ADA Curb Ramp New Construction Inspection Form (Parallel)

NW West Union

23885.56

NW Stewart LN

PARALLEL RAMP (PL)

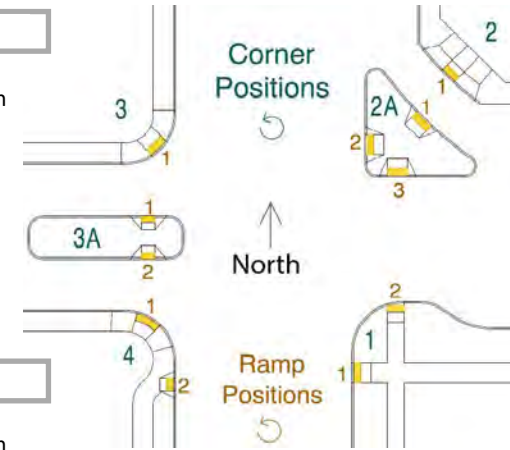
5.9 $\leq |5.0\%|$ ☐ $> |5.0\%|$ ☒

9.6 $\leq 8.3\%$ ☐ $> 8.3\%$ ☒

DWS IITD Fails turn space
